SERVICE BULLETIN

N° 189-188

ATA 30 – WIPERS AND WINDSHIELD WASHING KIT

This Service Bulletin is issued in order to provide the necessary instructions on how to perform the installation of the kit wiper for glass windshield P/N 8G3040F00311 and kit windshield washing P/N 8G3040F00211.

Figure 6

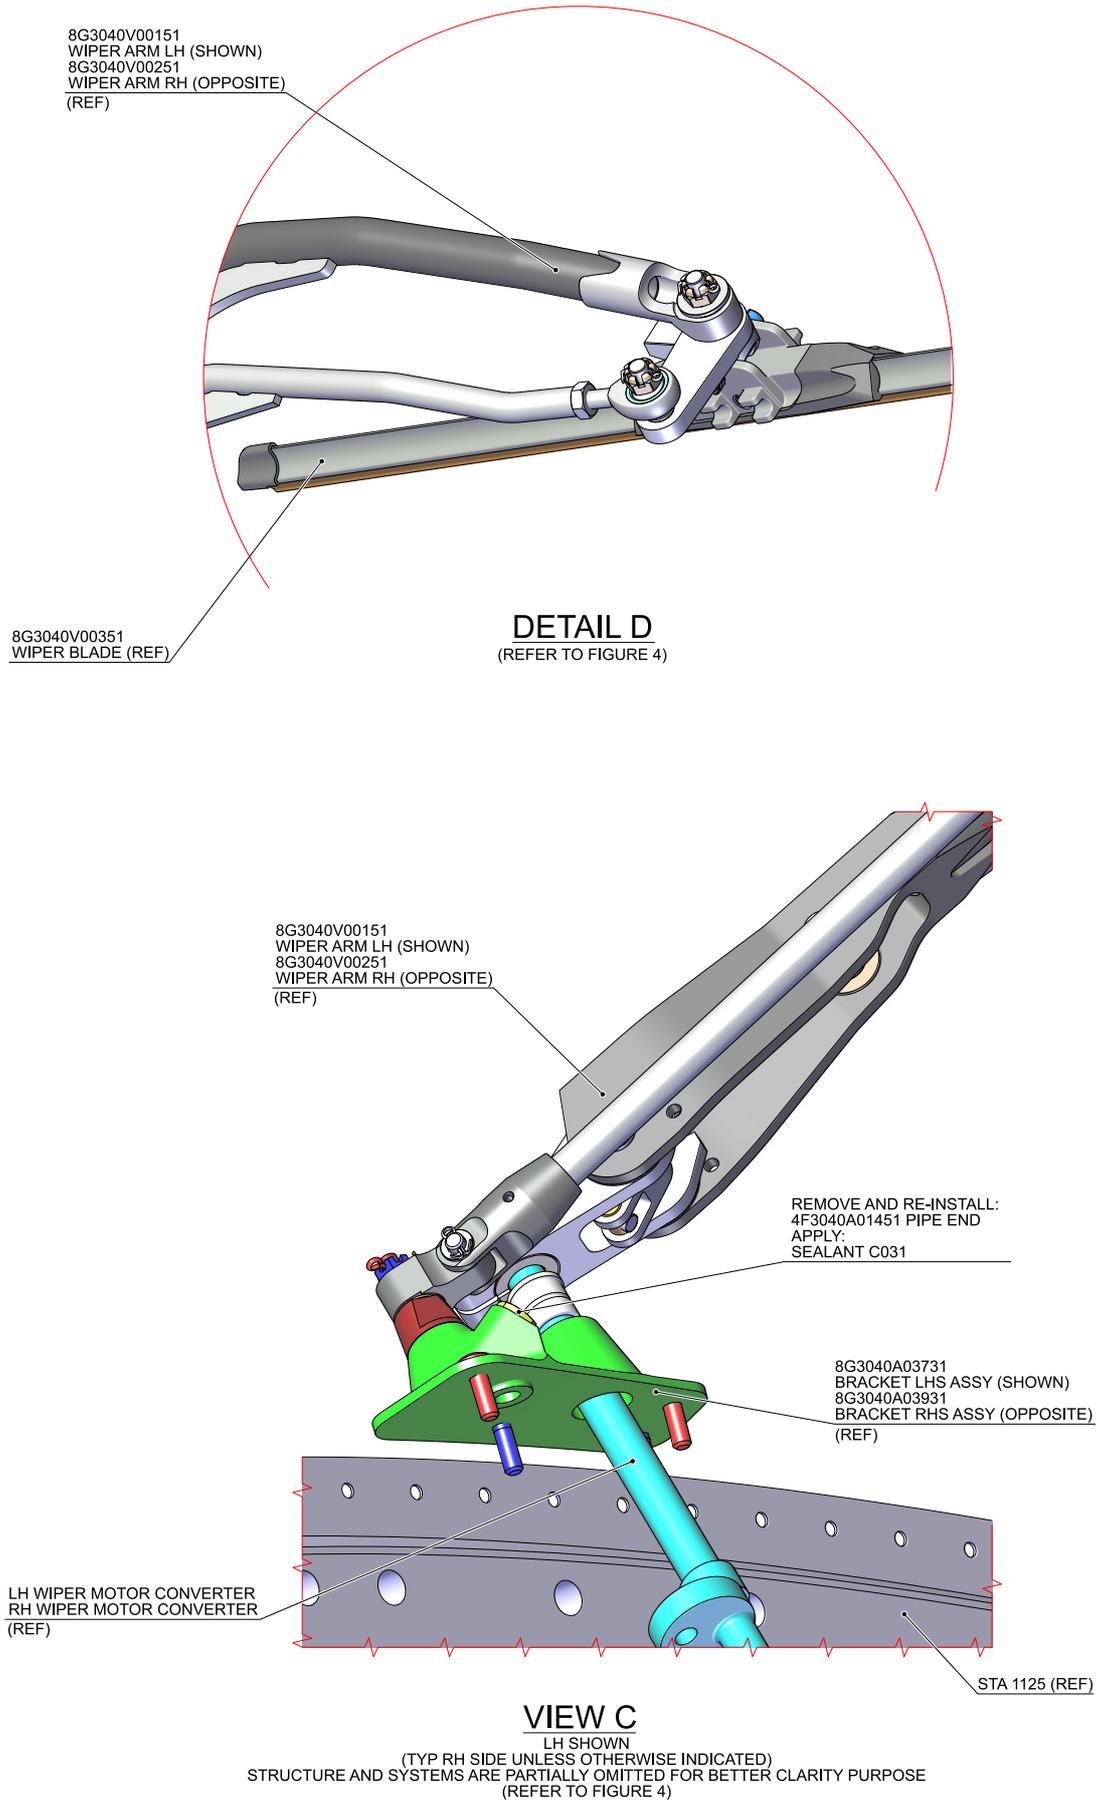
- 2.5 With reference to Figure 6 View C, remove and retain the pipe end P/N 4F3040A01451 from the bracket LH P/N 4F3040A00851.
 - 2.6 With reference to Figure 6 View C, remove and retain the pipe end P/N 4F3040A01451 from the bracket RH P/N 4F3040A00851.

- 3.2 With reference to Figure 6 View C, re-install the pipe end P/N 4F3040A01451 previously removed on the bracket LHS assy P/N 8G3040A03731 by means of sealing compound C031.

- 3.4 In accordance with the applicable steps of AMP DM 89-B-30-41-02-00A-920A-A and with reference to Figure 4 View A and Figure 6 Detail D, install the wiper blade P/N 8G3040V00351 on the wiper arm LH P/N 8G3040V00151.
